**STATE OF HAWAII  
DEPARTMENT OF TRANSPORTATION  
HIGHWAYS**

**ADDENDUM NO. 1  
FOR  
INTERSTATE ROUTE H-1, MCCULLY STREET SEPARATION,  
SEISMIC RETROFIT  
FEDERAL-AID PROJECT NO. NH-H1-1(284)  
DISTRICT OF HONOLULU  
ISLAND OF OAHU**

**May 1, 2026**

1. Install lower nut in contact with top plate and then back off 1/2 turn. Install upper nut snug tight to prevent lower nuts from loosening.
2. Minimum distance from any field welds to elastomeric polymer shall be 1 1/2".

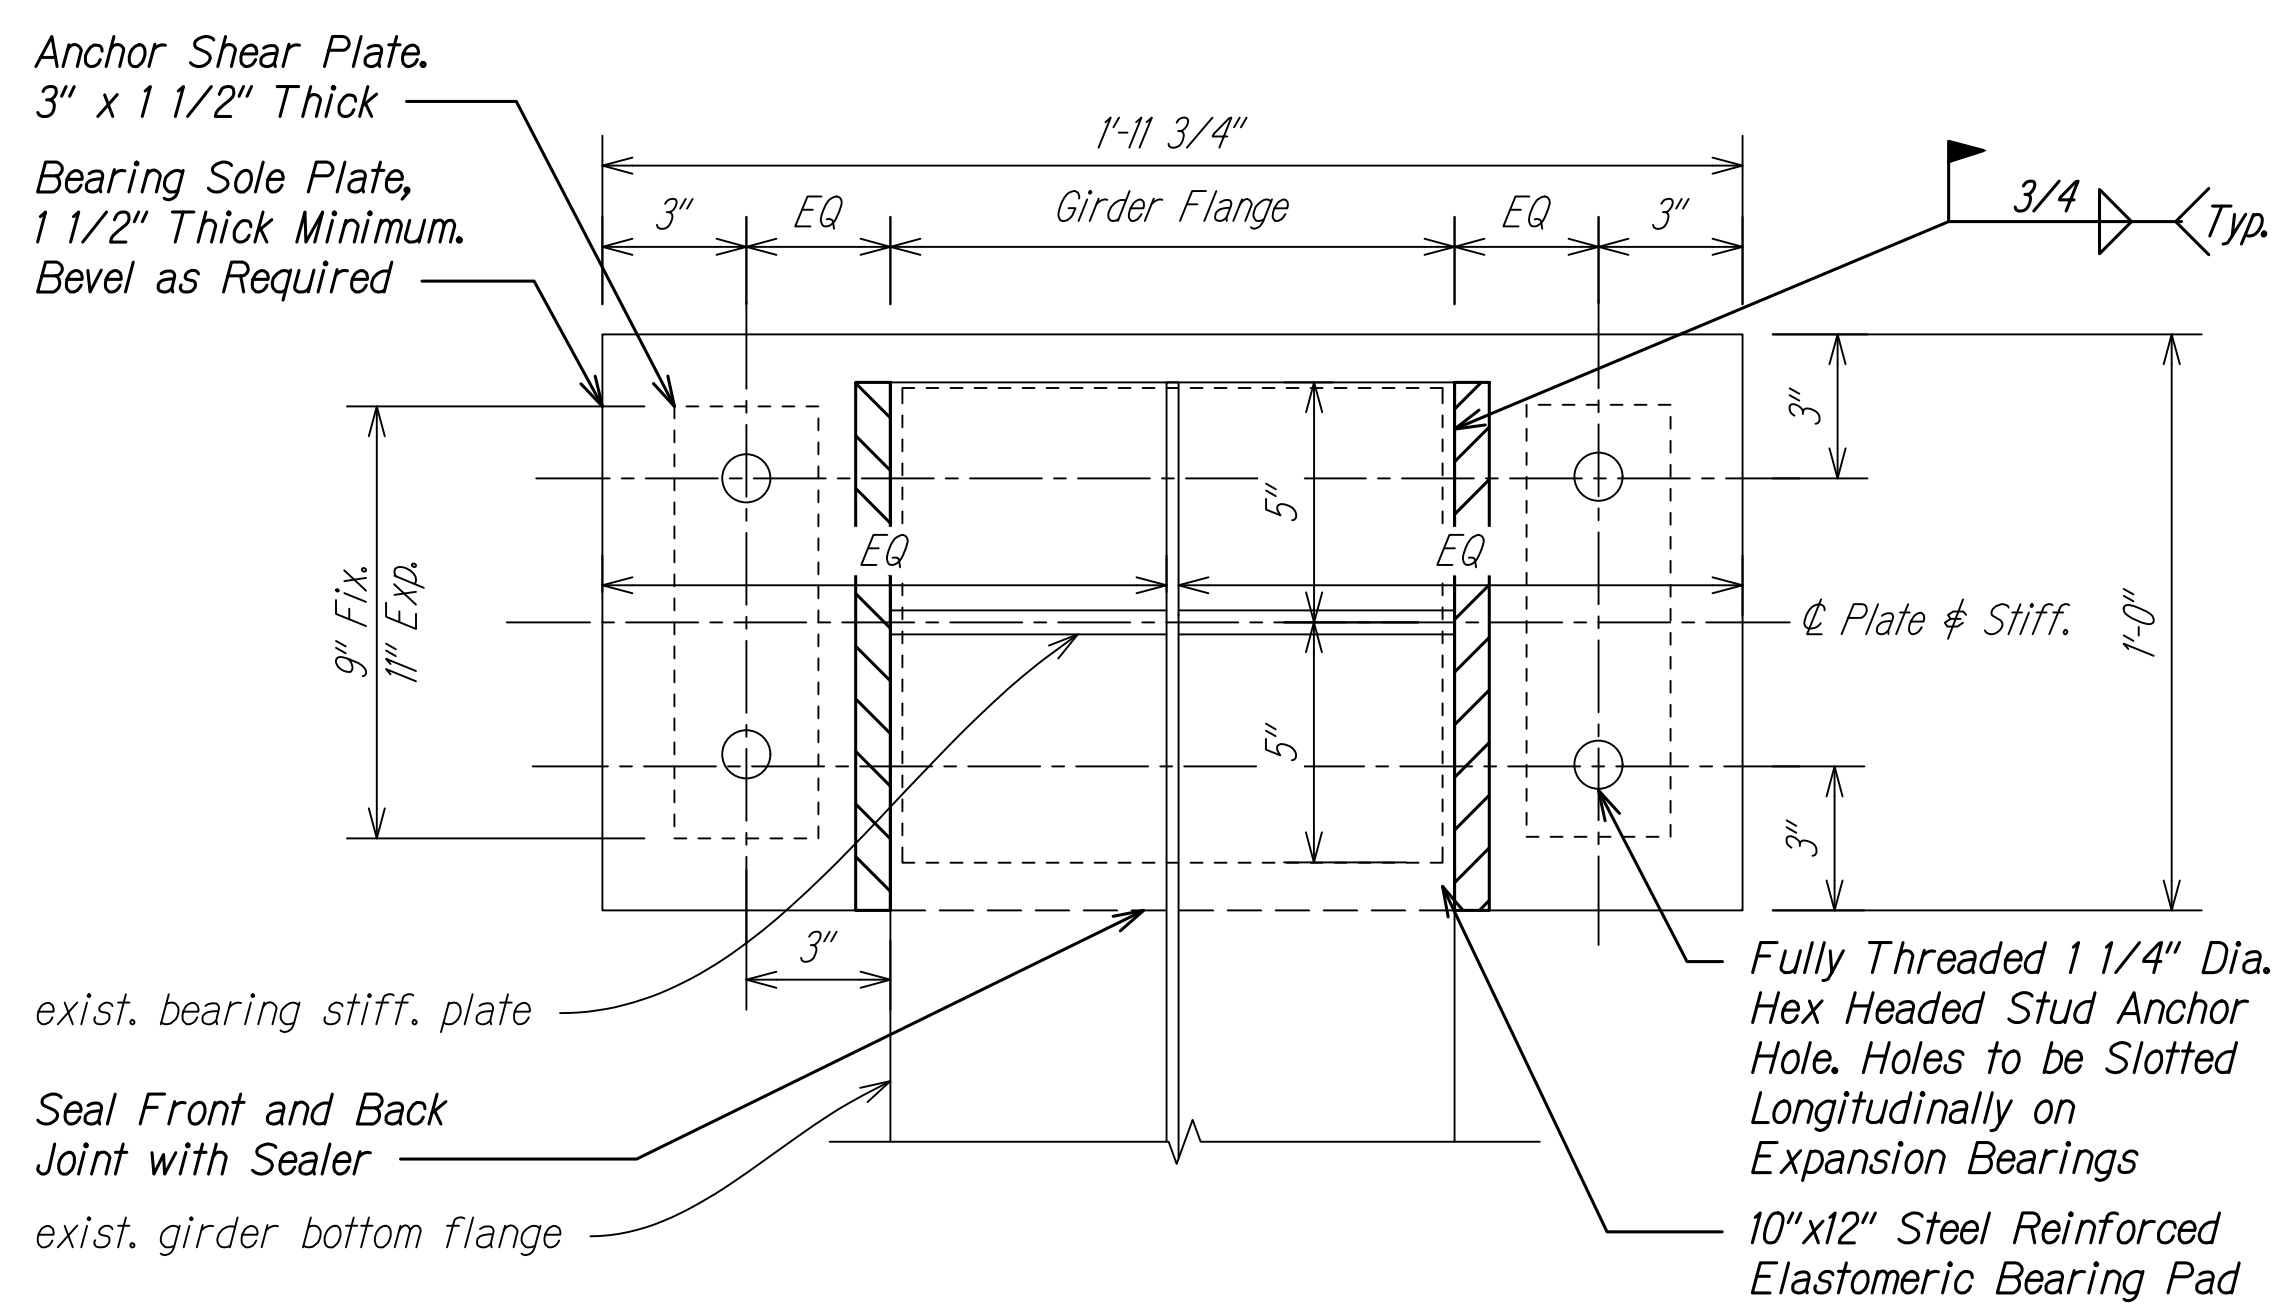
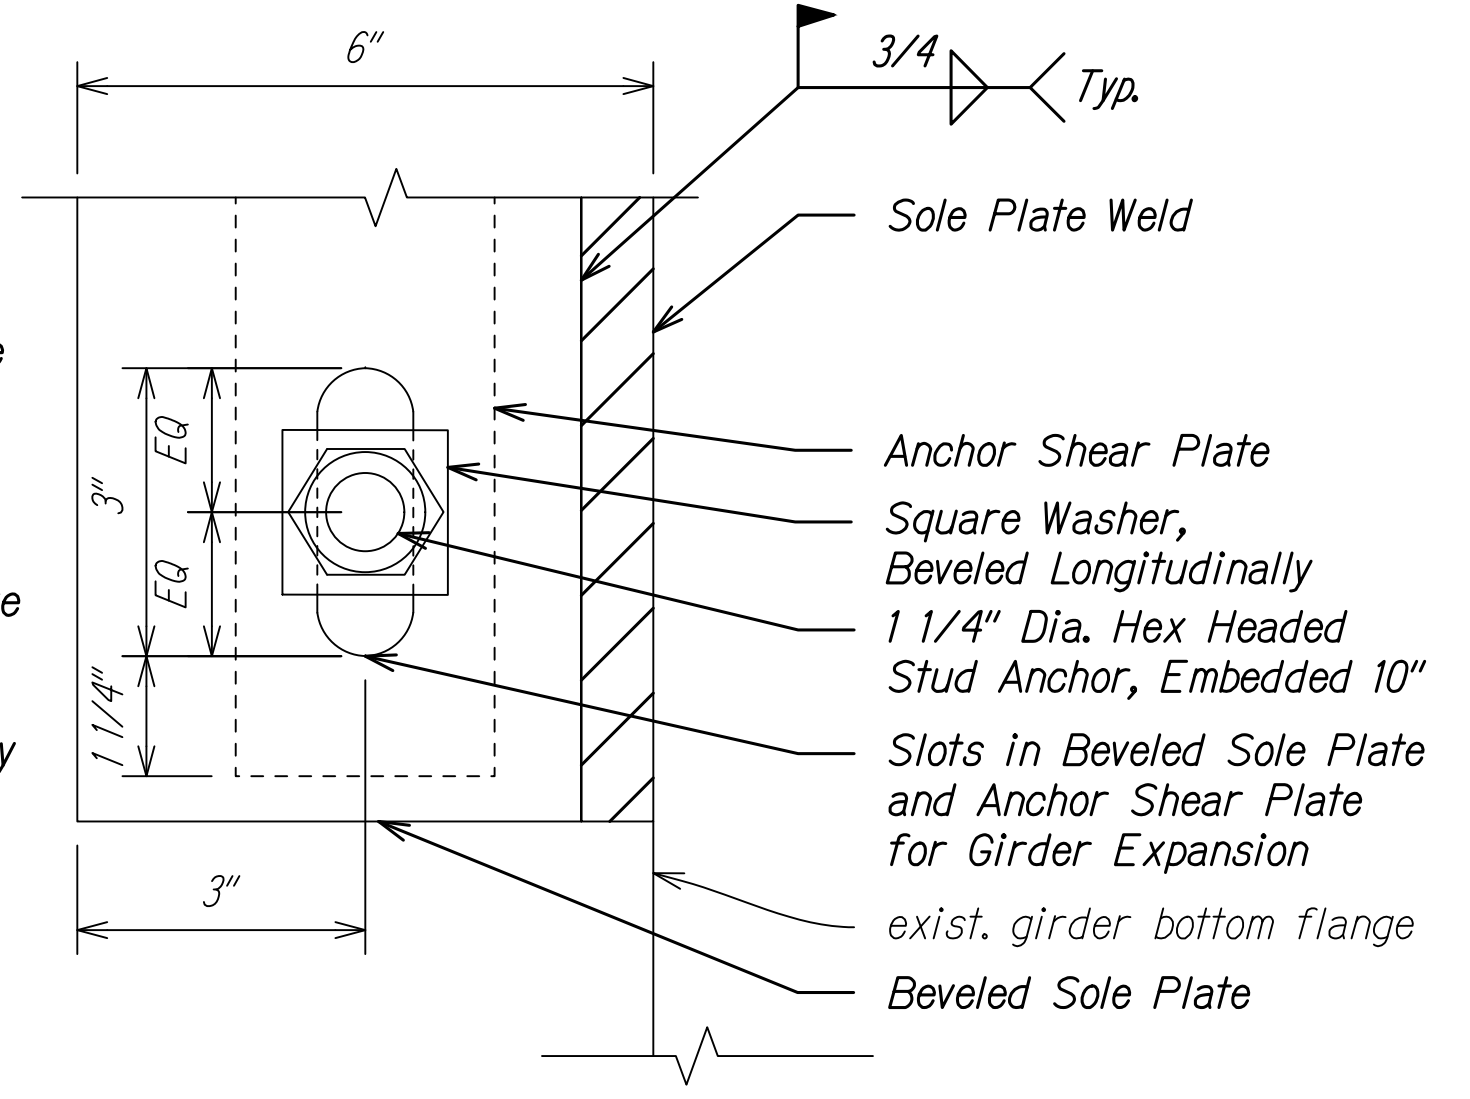
4/21/26	Added grout pad extension dimensions. Rearranged C/S-24 and C/S-24 and revised notes.
DATE	REVISION

10. Grout pad shall extend a minimum of 1 1/2" horizontally on all sides of the bearing.
11. Stud anchor lengths vary by location due to the beveled sole plate. All stud anchors shall meet the minimum embedment of 10" and extend at least 3 full threads above the double nut.

**SEAT LAYOUT AND SEAT ELEVATIONS**

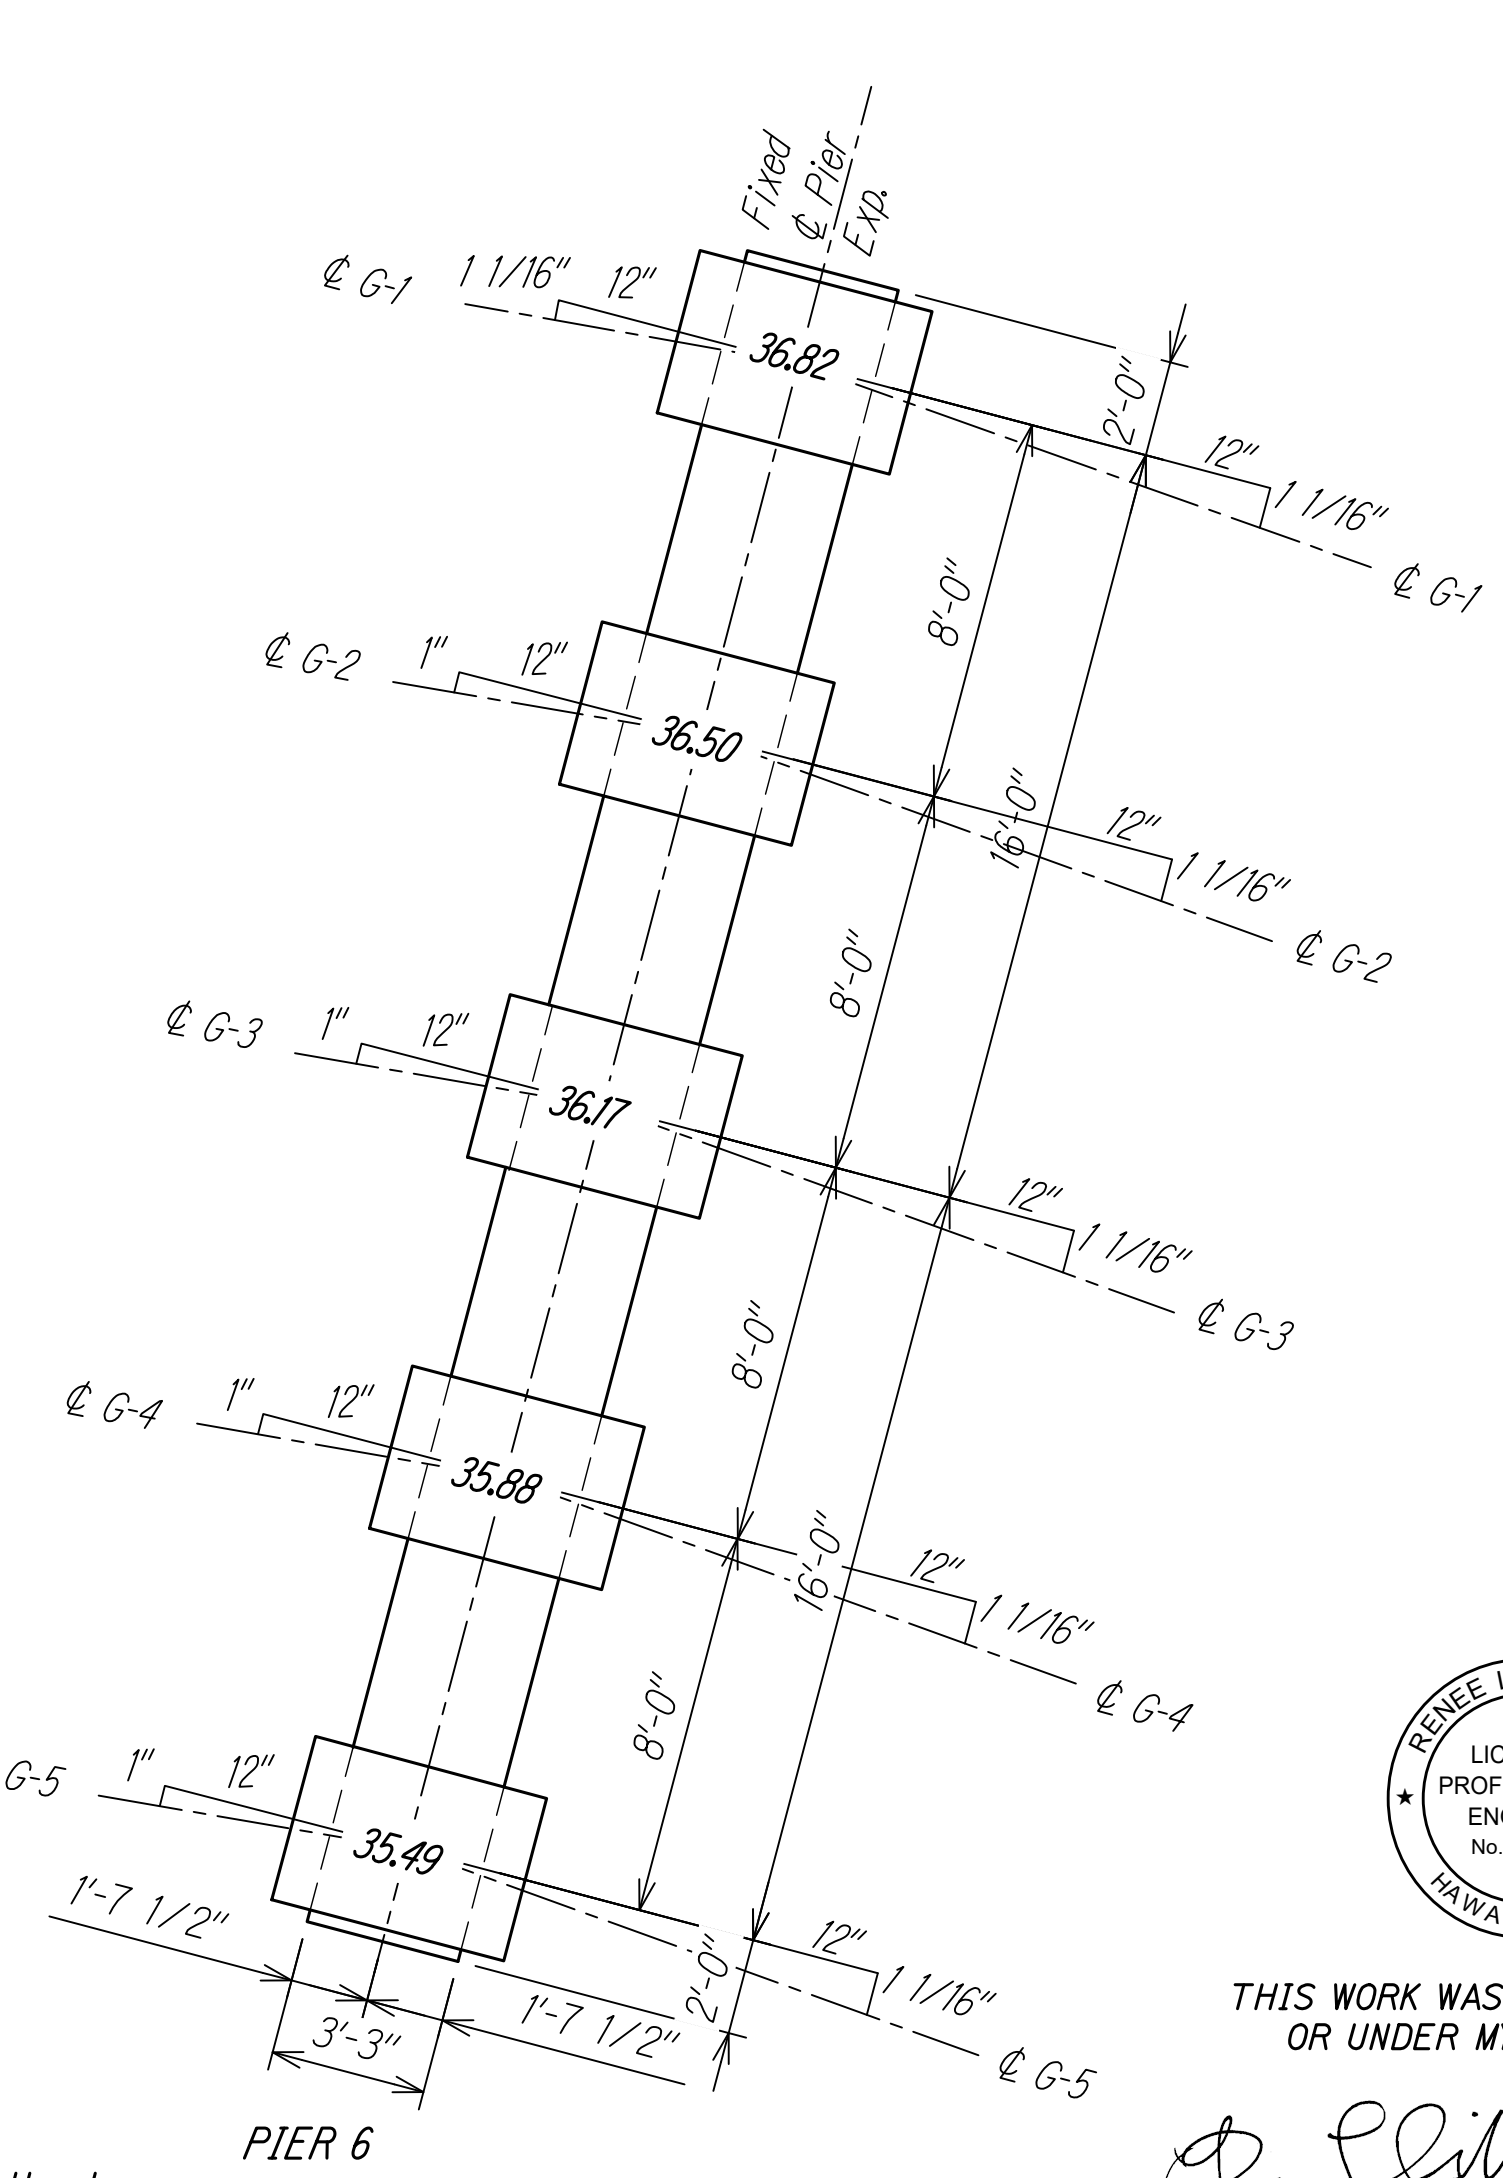
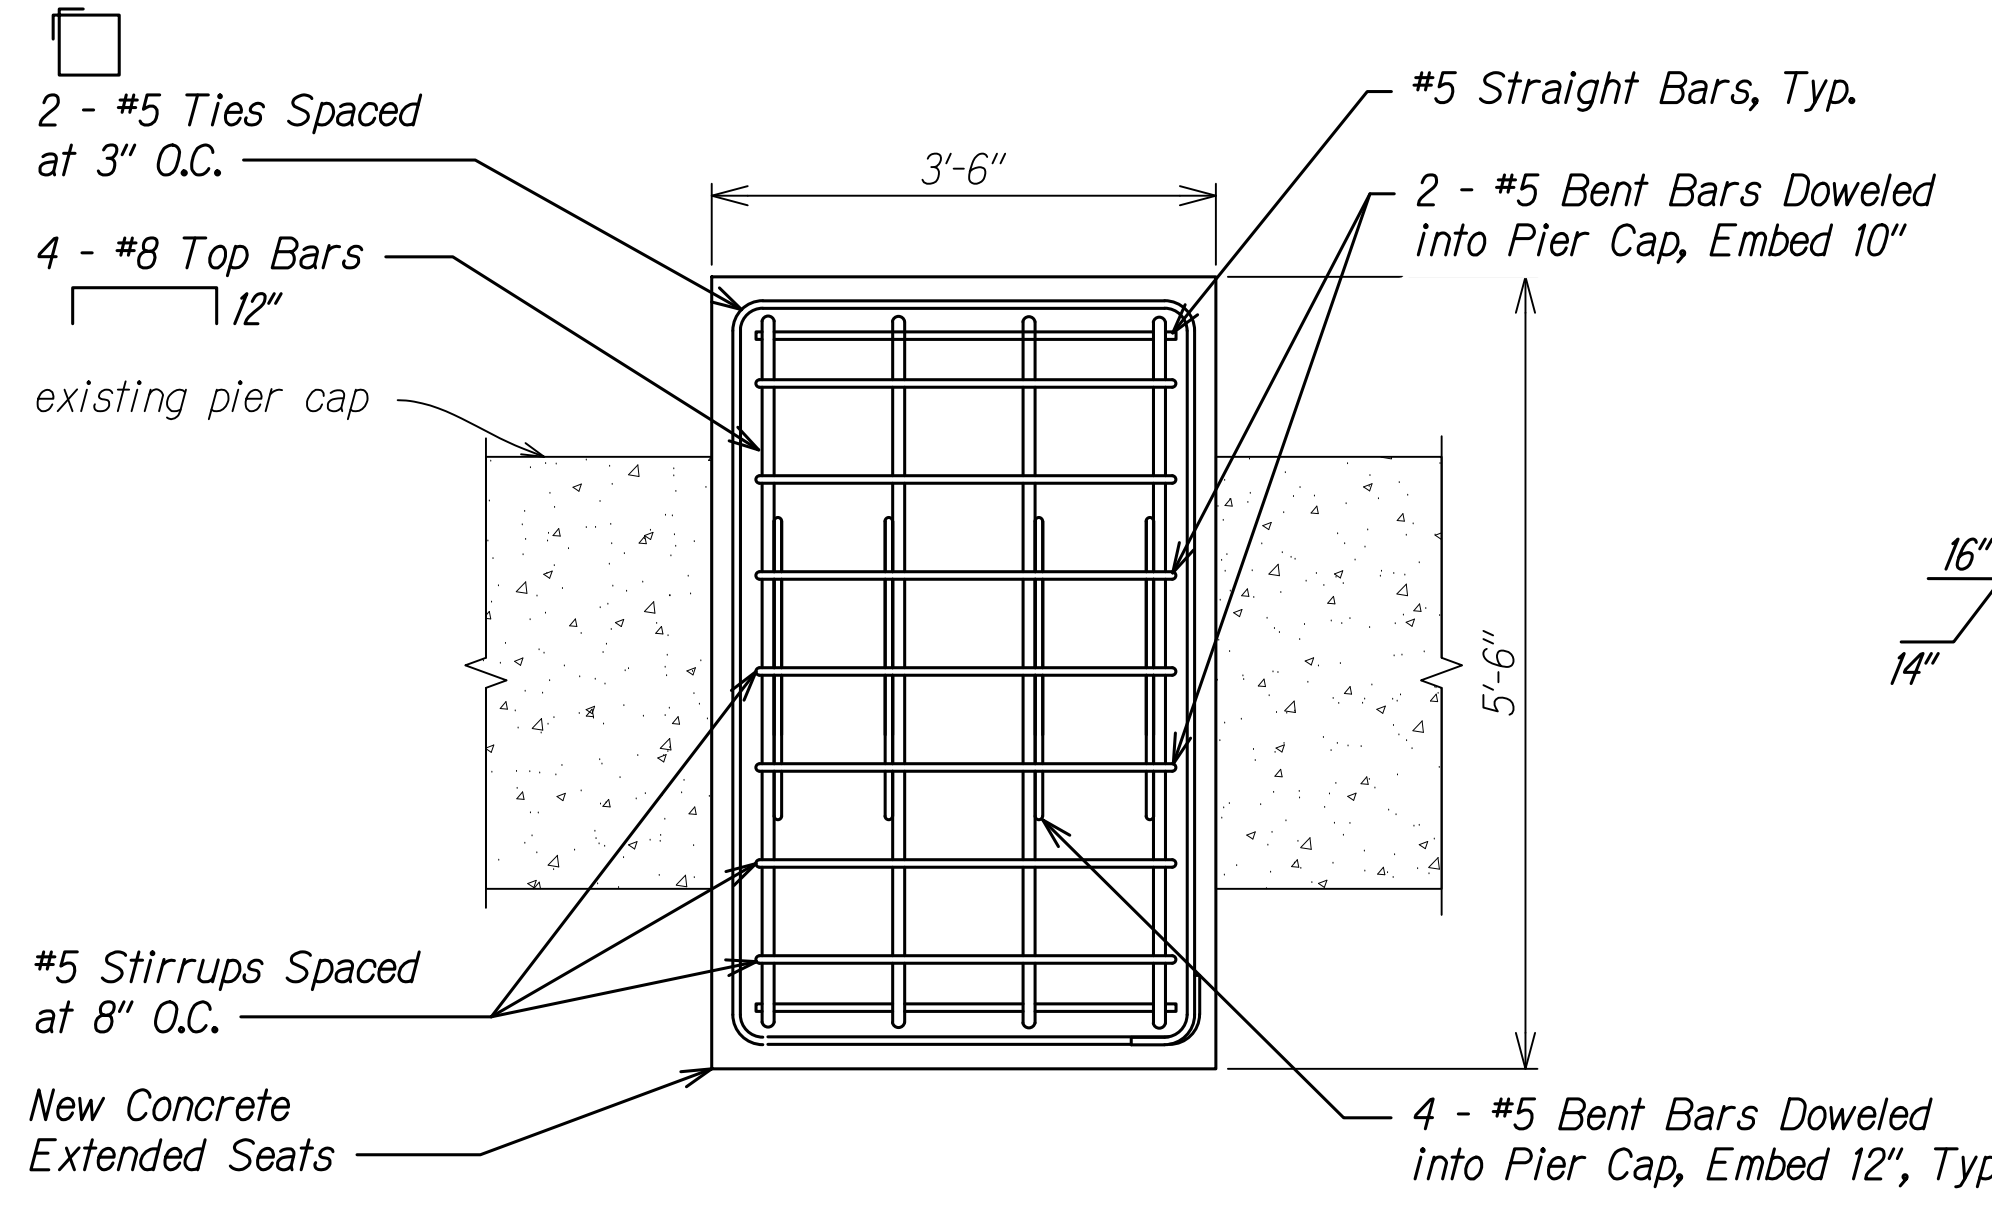
4/21/26	☐ Provided grout pad extents
DATE	REVISION
